RE: Request for an amendment to the Final Plan for Country Club Town Homes

RE: Final Plan Amendment for County Club Townhomes

FILE #FPA-95-183

TITLE HEADING: Final Plan Amendment - Country Club Townhomes

FPA-95-183
Country Club Townhomes
Final Plan Amendment
Revised Grading and Drainage Plan
(Enlarged View)

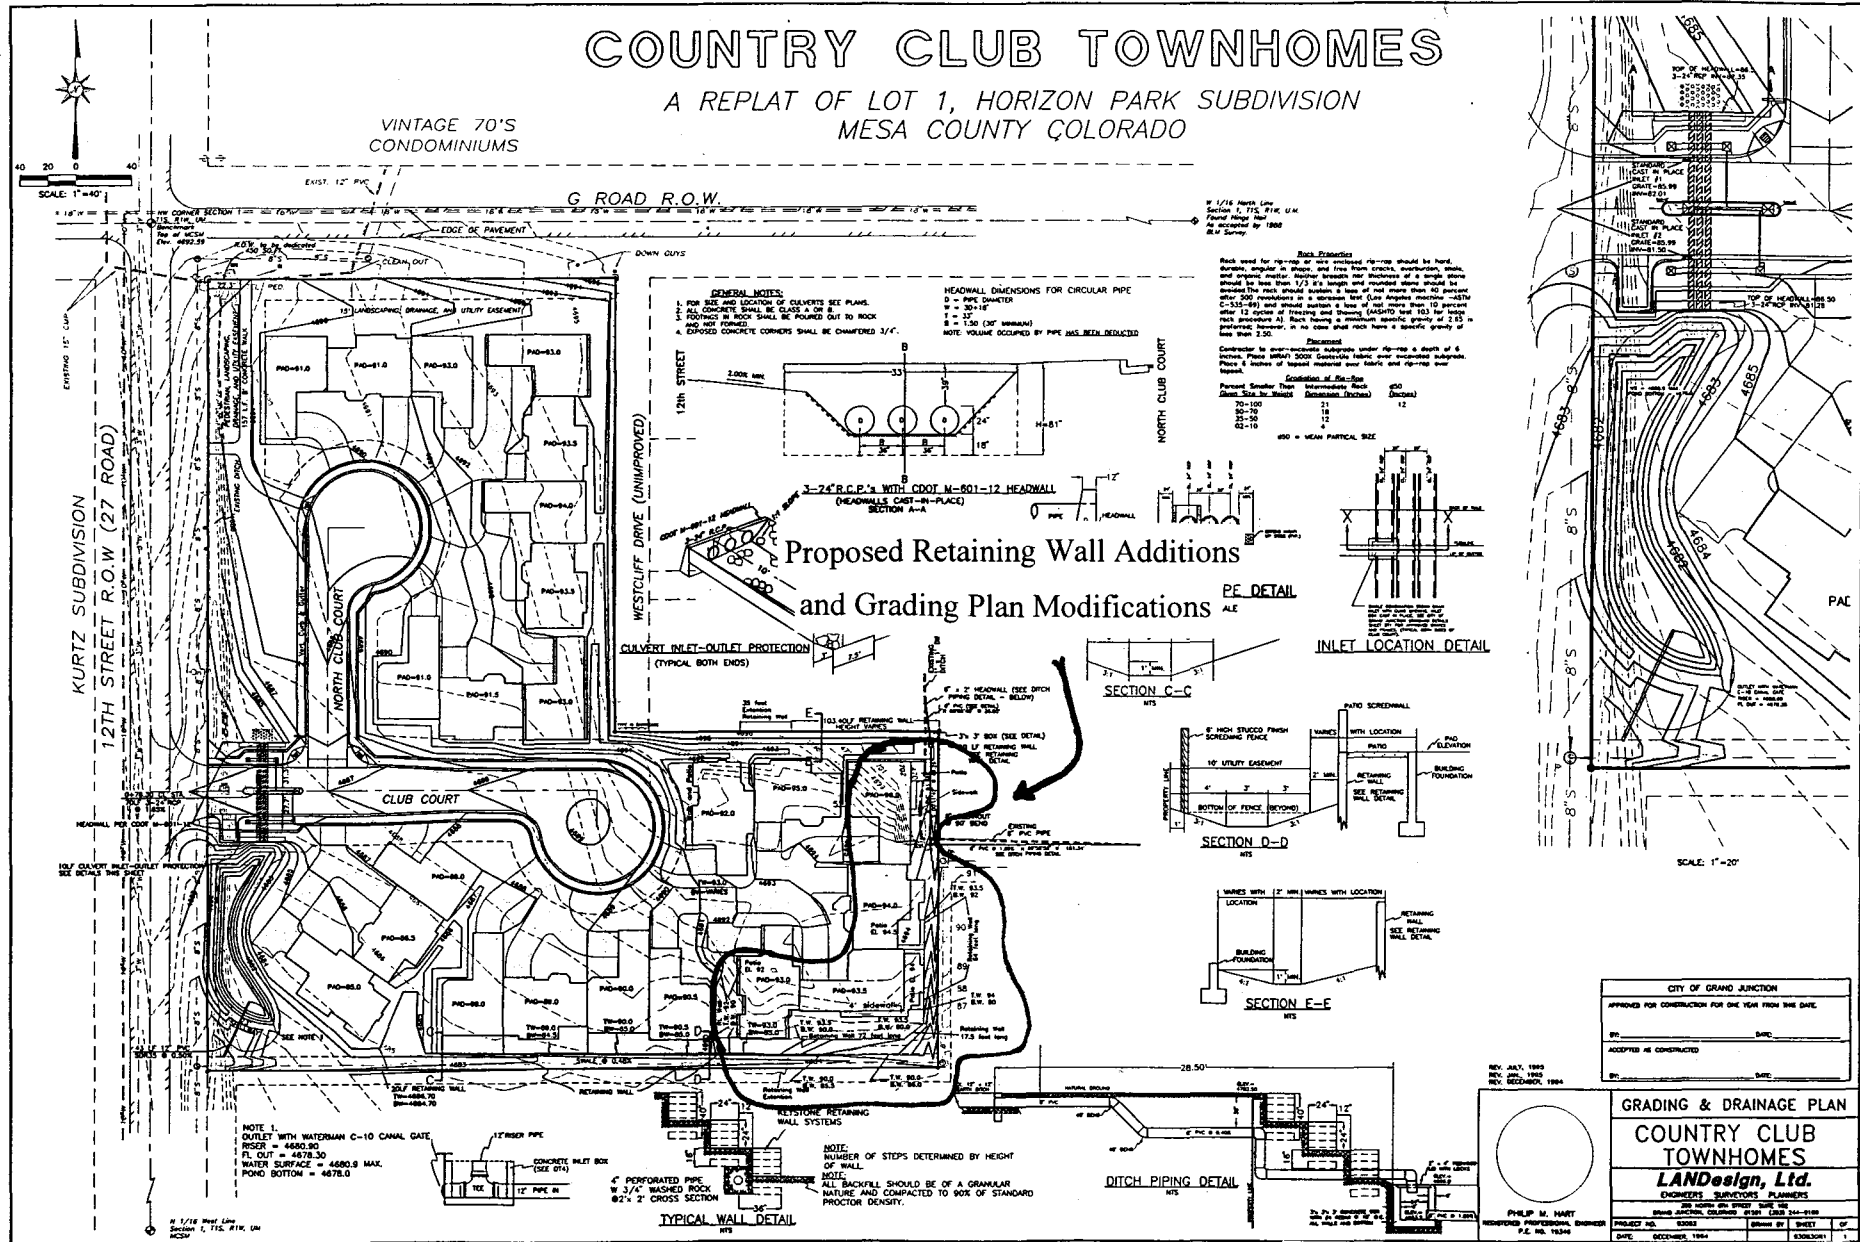
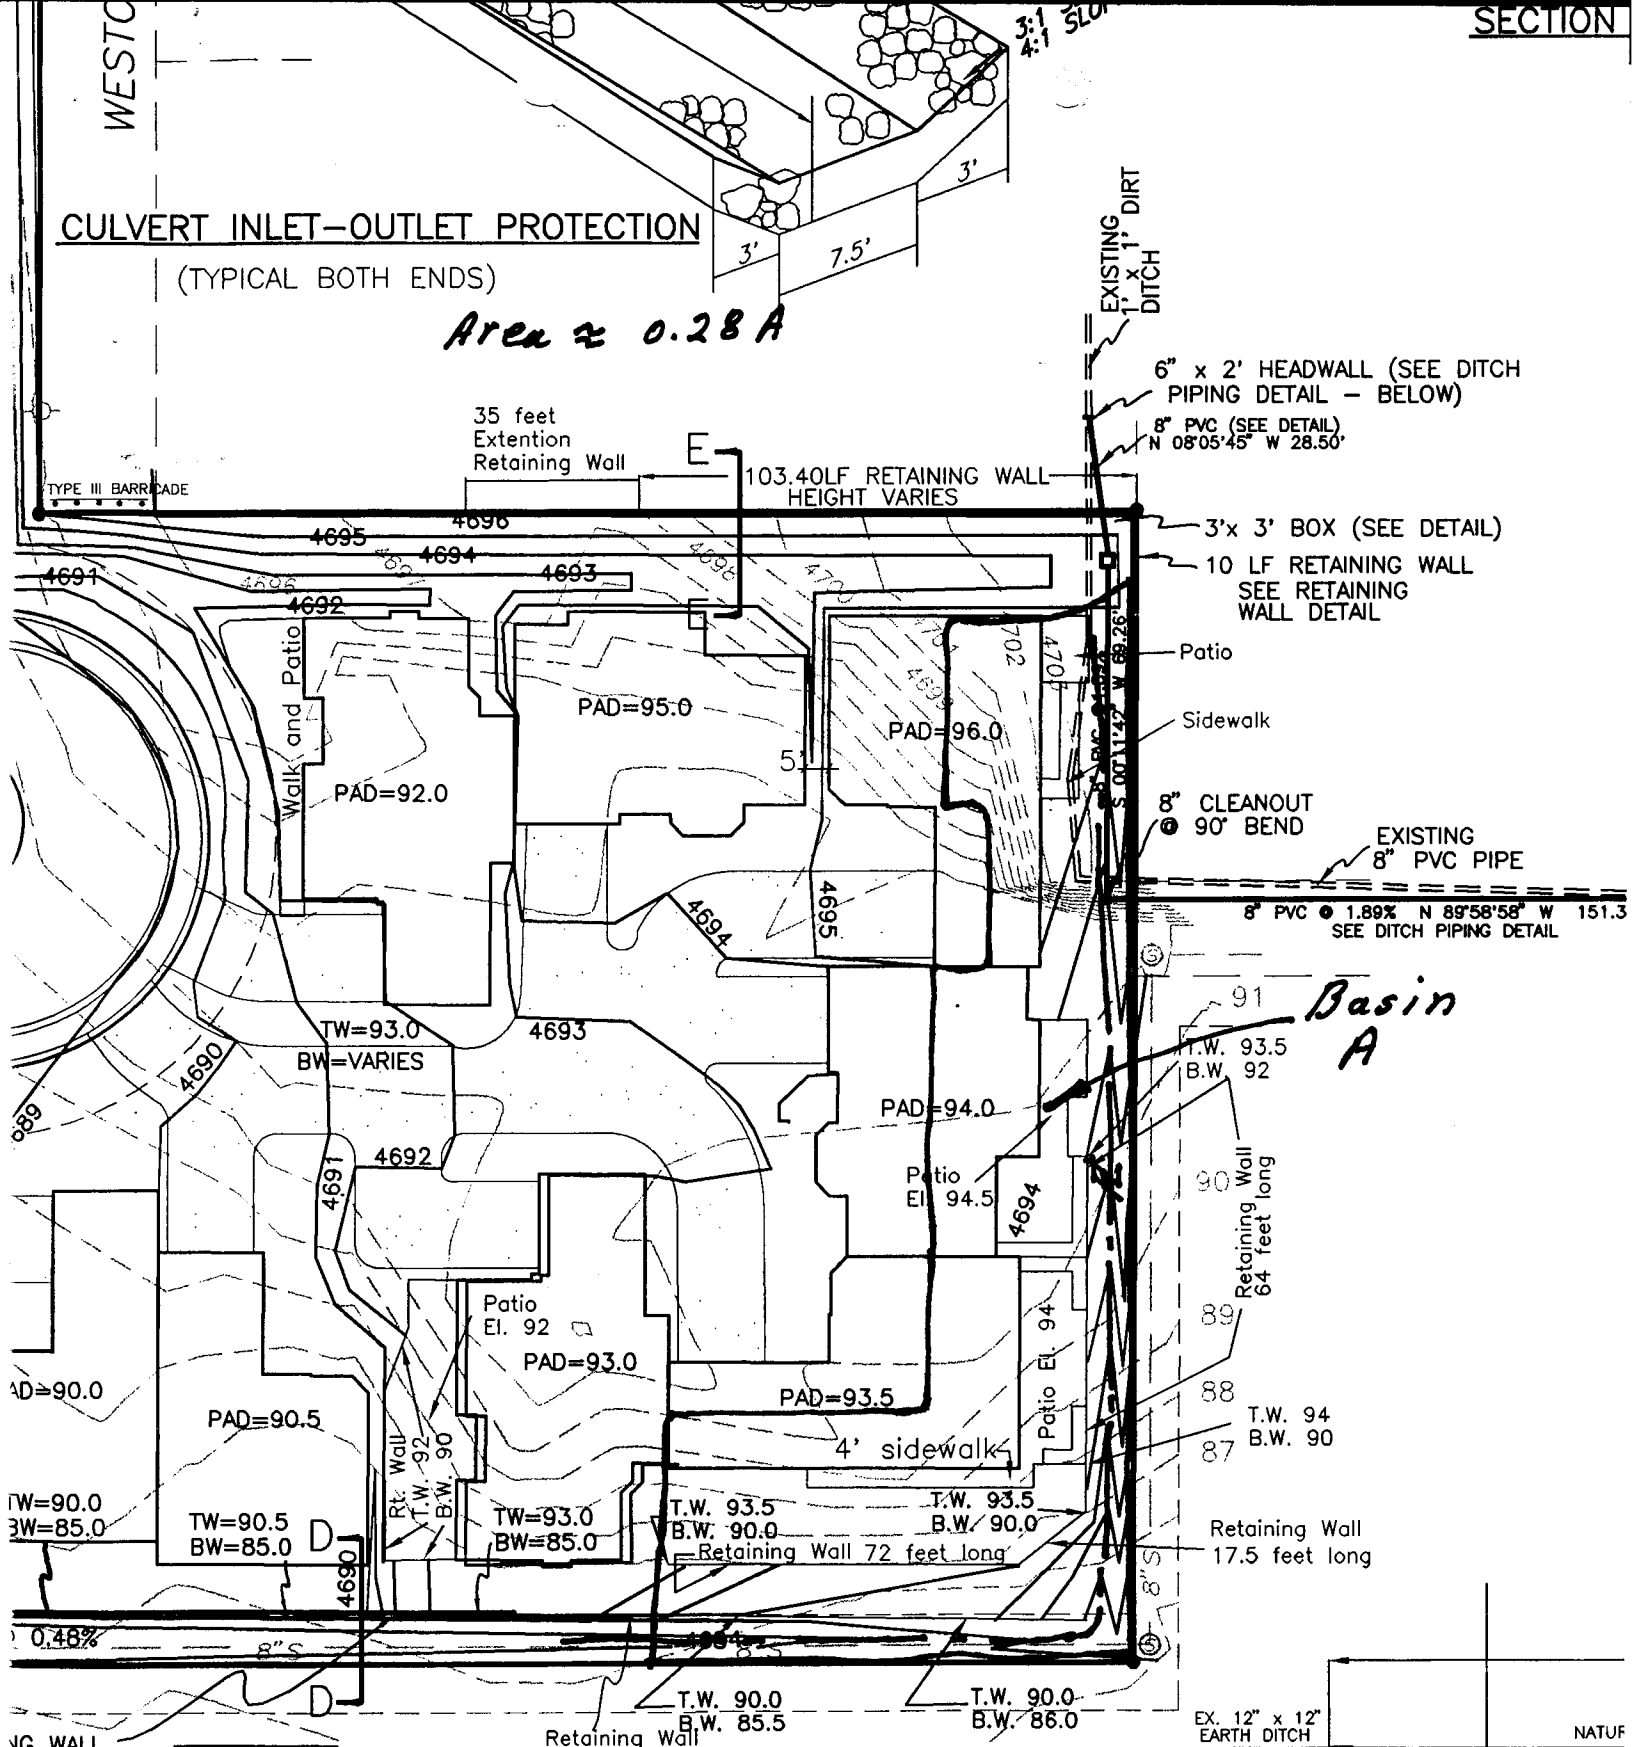
Item Two: The 6 foot high stucco screening fence shown in section D-D is a drafting error. The fence was part of a previous design alternative and was not removed from the Grading Plan. There was never any intent to construct the stucco fence at this Site.

1. Drainage calculations for modified ditch section were not provided as requested and discussed at the meeting prior to submittal.
2. What is the extent of the 6' high stucco finish screening fence shown in section D-D? It is not called out on the plan.
3. What is the purpose and timing of the phasing? We currently have an improvements agreement which guarantees all of the improvements, and the plat was recorded for the entire project based on that guarantee.

Item One : Please find attached the drainage calculations for the modified drainage ditch.

Basin Map

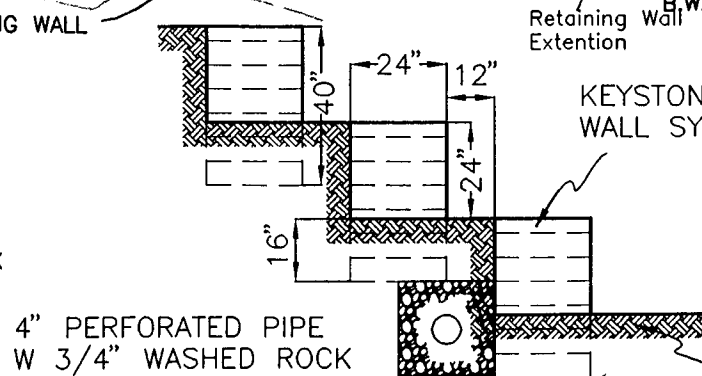
Pease find attached the drainage calculations for the drainage ditch along the east side of the Country Club Townhomes.

The soils at the site are classified by the Soil Conservation Service as Rp Chipeta Persayo Soil material Hard Platy Mancos Shale. The hydrological soil group is a "D". The drainage ditch has more than enough capacity for the 100 year storm event.
